NORTH WITNEY HOUSING DEVELOPMENT

Challenges and Interventions

(Version 2 – May 2024)

Issued as a response to planning application 24/00482/OUT and as a consultation document with local councils that support WING.

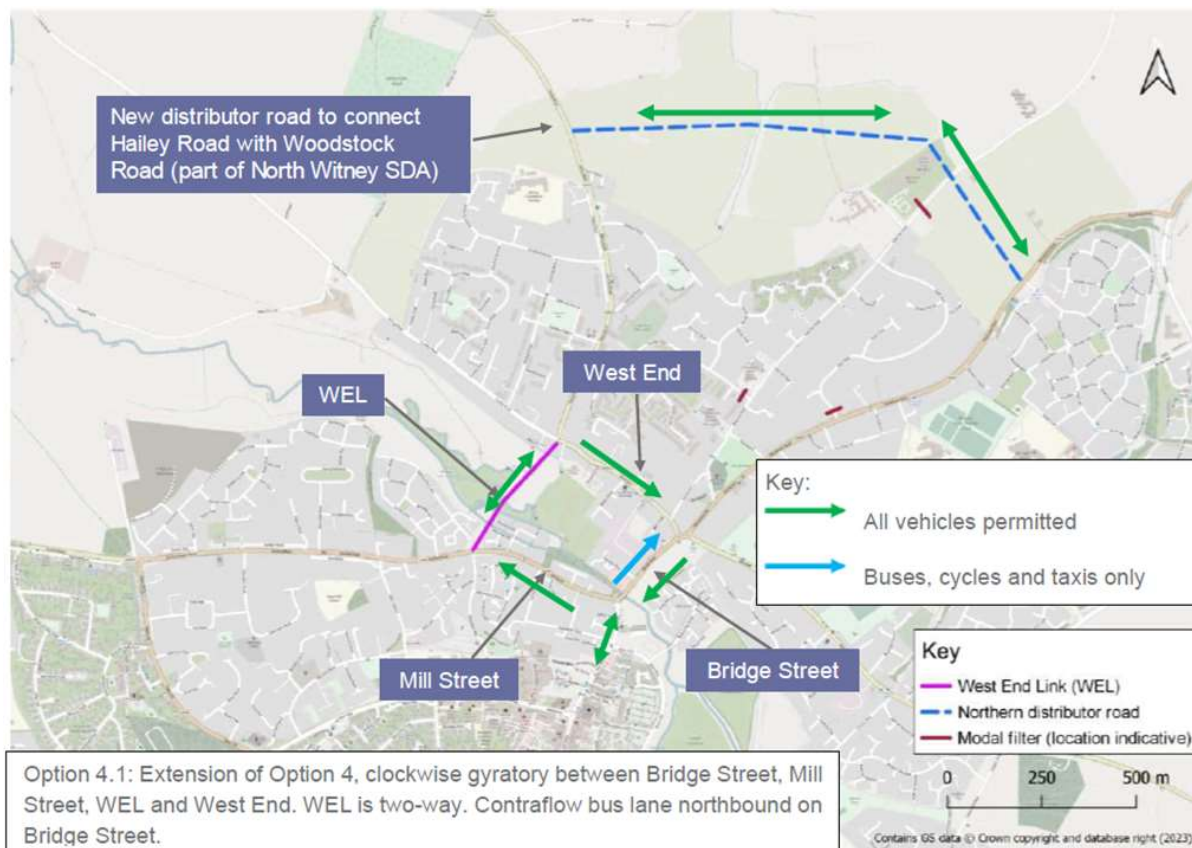
The developers applying to build the North Witney housing estate have omitted the WEL, citing Oxfordshire's Local Transport and Connectivity Plan 2022-2050 [4], which discourages the construction of new roads unless necessary.

The impacts of building 1400 houses *without* a second river crossing are likely to include:

- Increased congestion on West End, Bridge Street, Woodstock Road and Newlands into and out of Witney.
- Increased NO₂ levels and concomitant particulate pollution on Bridge Street, the Air Quality Management Area which has an Air Quality Action Plan [10], [11], that cites the WEL as part of the measures expected to bring Bridge Street air quality up and NO₂ levels down to compliance with national objectives.
- A missed opportunity to dovetail flood mitigation measures at the river.
- A missed opportunity to improve walking and cycling routes to connect residents to Witney.

WING takes the position that the WEL must be a prerequisite of the development going ahead. This might take the form of a planning condition or a reason for refusal of the plans in their current form.

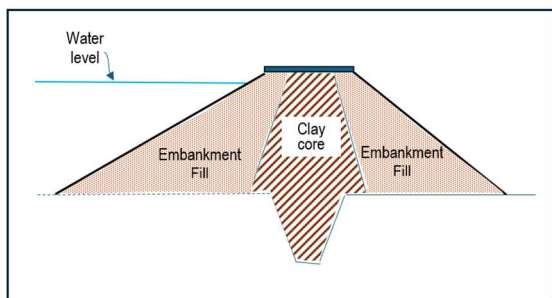
The final option was for a full embankment with restricted openings that would match the size of the opening under the bridge in Bridge Street. There was an intention to keep the flow balanced – matching what came in with what could go out. However, the size of the restricted openings did not consider two additional flows into the area between the WEL and Bridge Street. These were the Hailey Road Drain and a ditch behind properties in Crawley Road that links to Hailey Road Drain. Because of these omissions, more water could flow into the risk area than could escape and the analysis showed that the area between the WEL and Bridge Street still flooded.

This last option demonstrated that water could be retained upstream of the WEL but identified a problem with the Crawley Road ditch. There is a low bank between this ditch and the flood plain. As the flood plain fills, water will quickly overtop this bank, flow into the ditch and on into the Hailey Road drain. This will add to the flood between the WEL and Bridge Street. In effect, the Crawley Road ditch acts as an outfall from the flood plain which limits the volume that can be retained upstream of the WEL.

The Level 2 SFRA conclusions recognised that further options were possible and stated that “there would be merit in investigating the viability of other more engineered flood alleviation solutions”. WING would strongly support this approach and suggest that an option would be to:

Current arrangement

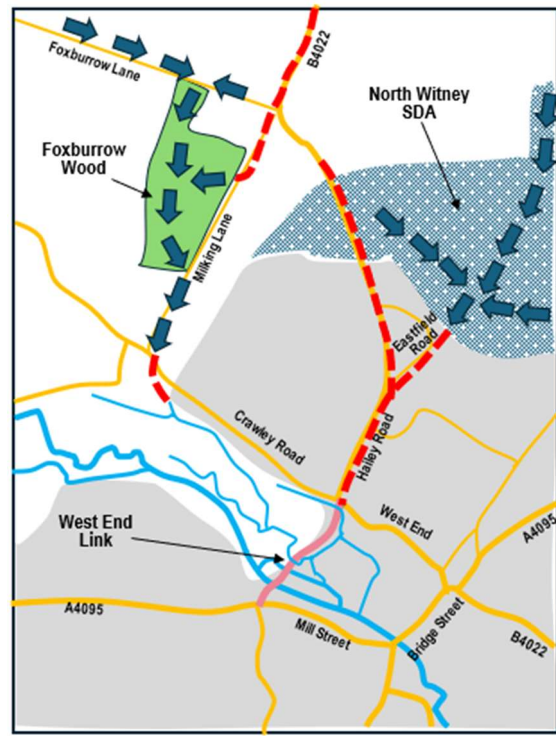
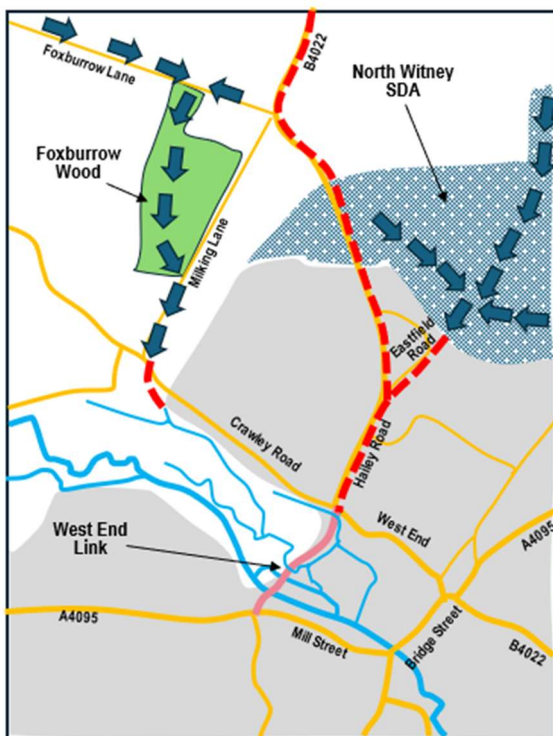
The 750mm diameter drain from the junction of Eastfield Road with Hailey Road down to the outfall into the basin area above Bridge Street is the focus for this table. Currently this length of piped drain becomes overloaded in periods of severe rainfall and overflows from the manholes onto the road surface. The outfall from the drain into the basin is also restricted because the basin is in flood. Consequently, more water backs up in the drain. The roundabout at the bottom of Hailey Road becomes flooded and impassable.

Intervention Number	Description	Outcome/Comment
Interventions downstream of Hailey Road Drain		
HR1	Clear the obstructions and flooding issues downstream of Hailey Road to ensure there is a clear outfall into the basin.	This target should be achieved through completion of the Bridge Street interventions 1-6 as listed in the table above.
Interventions at Hailey Road Drain		
HR2	Consider measures to increase the capacity of the drain.	A complete reconstruction of this drain would be expensive and extremely disruptive. WING's proposal is that this action could not be justified.
Interventions upstream of Hailey Road Drain		
HR3 (linked to Bridge St Intervention No.7)	Reduce the peak flow entering the Hailey Road drain from North Witney housing area by constructing attenuation ponds in the development area.	A series of small attenuation ponds is indicated in the developer's proposals for North Witney housing. Although these may be adequate to limit the flow rate from the housing development into the existing piped drainage system and prevent an increase in flow, these proposals will not overcome the current flooding problems in the Hailey Road drain. Providing fewer, larger ponds to increase capacity would reduce flood risks for Witney. The current drainage arrangement floods during severe weather events. An element of improvement is therefore essential.
